Review of Western Sydney Airport Draft Environmental Impact Statement

26 November 2015

Document information
Client: WSROC Title: Review of Western Sydney Airport Draft Environmental Impact Statement Document No: 2269591A-ENV-REP-001 RevFINAL Date: 26 November 2015

Ground-based noise and vibration assessment peer review

Figure 3-3 - Comparison between modelled noise sources in 2063 (Appendix E2 Figure 3-4, top image) and indicative airport site layout in 2063 (Volume 1 Chapter 5 Figure 5-3, bottom image)

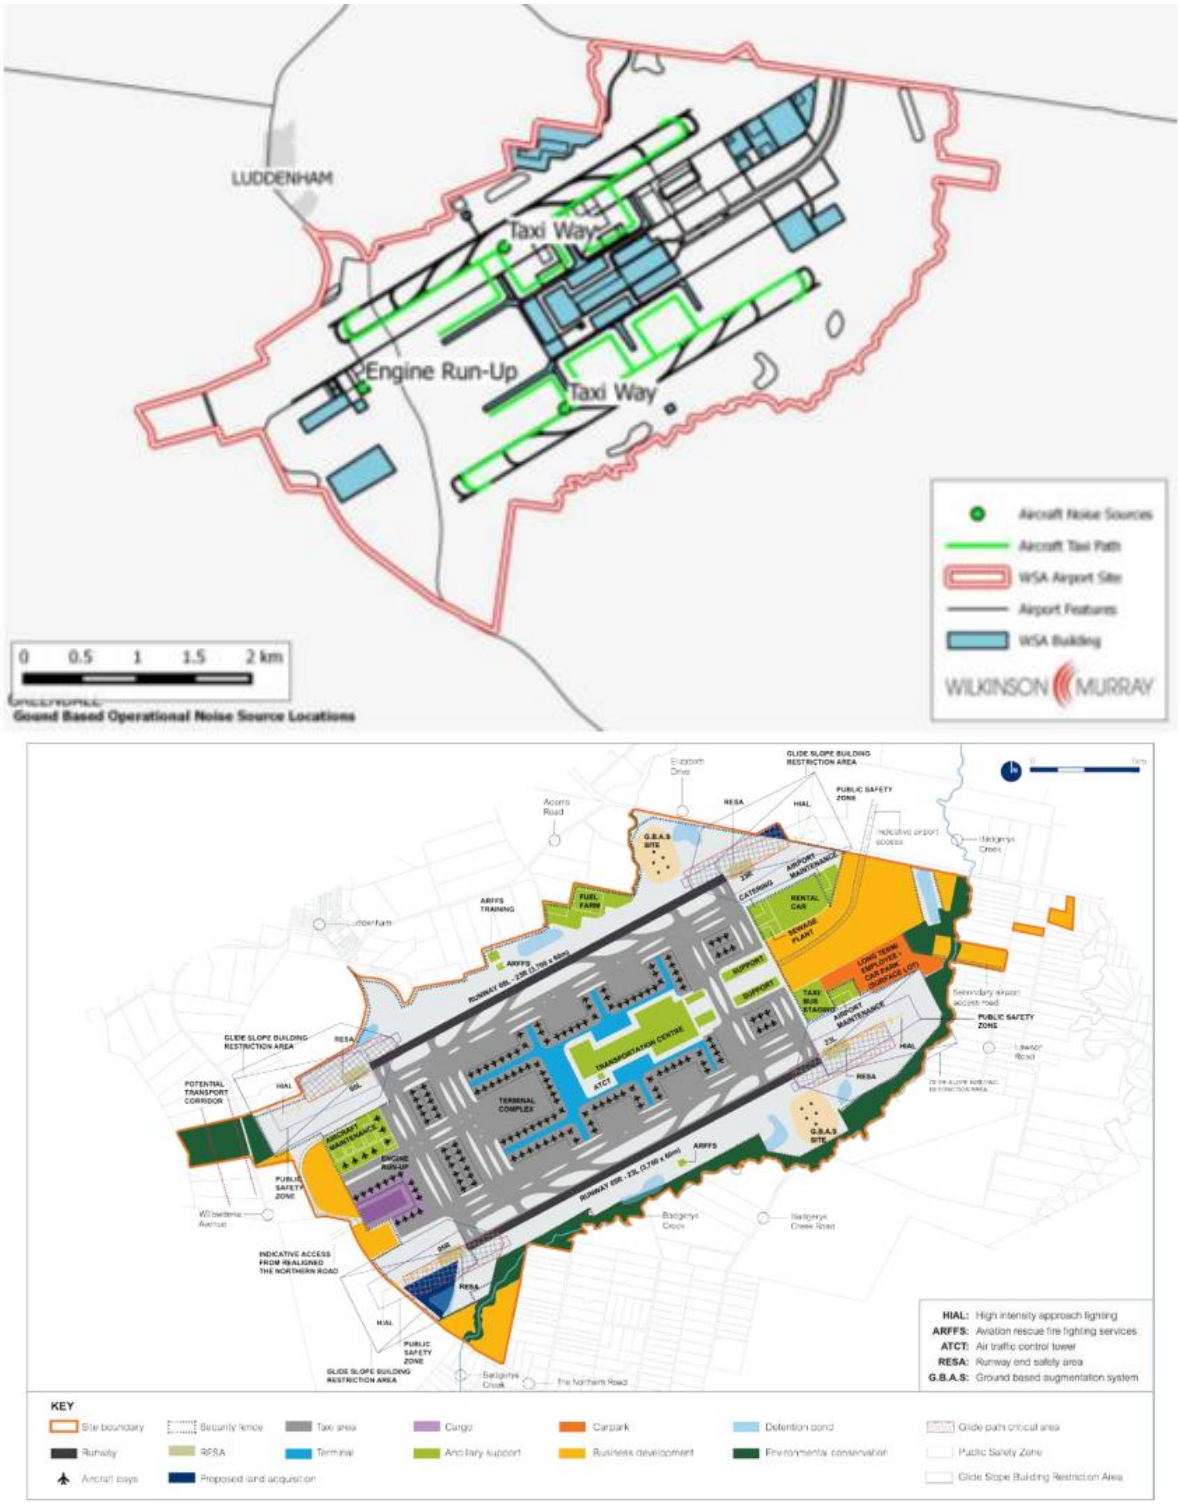
Figure 3-4 of Appendix E2 does not accurately represent Figure 5-3 of the draft EIS Volume 1 (p143) document which shows the indicative airport site layout – long term development. The two figures are compared in Figure 3-3 below. In particular, there are additional areas within that layout where aircraft would be taxiing that have not been included in the noise model. The model only accounts for the usage of 63 out of 95 aircraft gates. It is recommended that the model is updated to include the additional areas where aircraft will be taxiing. It is anticipated that there will be an increase of approximately 1 dB in including these additional areas.

3.7 / Figure 3-4	The figure shows ground-based operational noise source locations in 2063	The figure does not accurately represent Figure 5-3 of the EIS Volume 1 (p143) document which shows the indicative airport site layout – long term development. In particular, there are additional areas within that layout where aircraft would be taxiing that have not been included in the noise model. The model roughly only accounts for the usage of 63 out of 95 aircraft gates.	It is recommended that the model be updated to include the additional areas where aircraft will be taxiing.	Low
